PCN# 20210210002.1
Qualification of new Fab site (RFAB) using qualified Process Technology, Die Revision, and additional Assembly options for select devices
Change Notification / Sample Request

PCN Number:	20210210002.1	PCN Date:	Feb 12, 2021
Title:	Qualification of new Fab site (RFAB) using qualified Process Technology, Die Revision, and additional Assembly options for select devices		
Customer Contact:	PCN Manager	Dept:	Quality Services
Proposed 1st Ship Date:	May 12, 2021	Estimated Sample Availability:	Date provided at sample request.

Sample product shipping label (not actual product label)

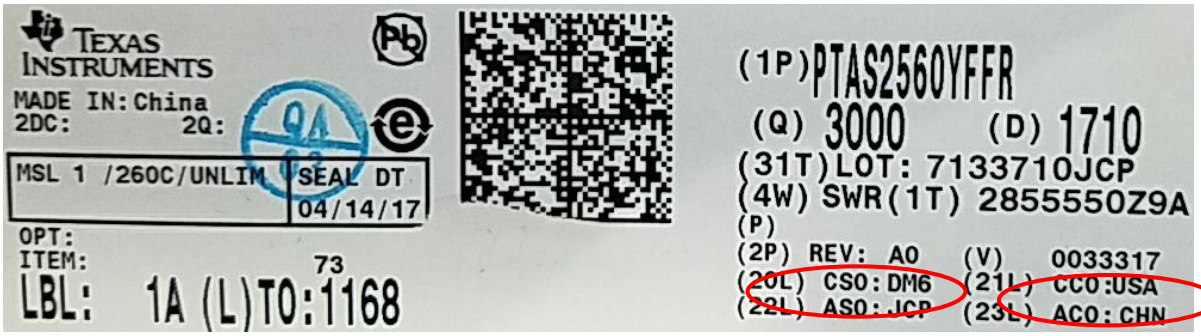
Changes to product identification resulting from this PCN:

Chip Site	Chip Site Origin Code (20L)	Chip Site Country Code (21L)	Chip Site City
DL-LIN	DLN	USA	Dallas
RFAB	**RFB**	**USA**	**Richardson**

Assembly Site	Assembly Site Origin (22L)	Assembly Country Code (23L)	Assembly City
UTL2	NS2	THA	Bangkok
TFME	**NFM**	**CHN**	**Economic Development Zone**
TIPI	**PHI**	**PHL**	**Baguio City**
